SEGA SERVICE

Field Service Bulletin Strike Fighter Deluxe Important Notice !!!

Apply Loctite at these points

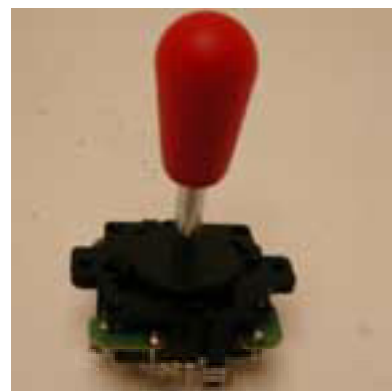
Problem: The Joystick used for the direction control (Camera Angle) on the Strike Fighter Deluxe is threaded and may come loose.

Solution: See the pictures below and install Blue Loctite (242) on the locations indicated ASAP.
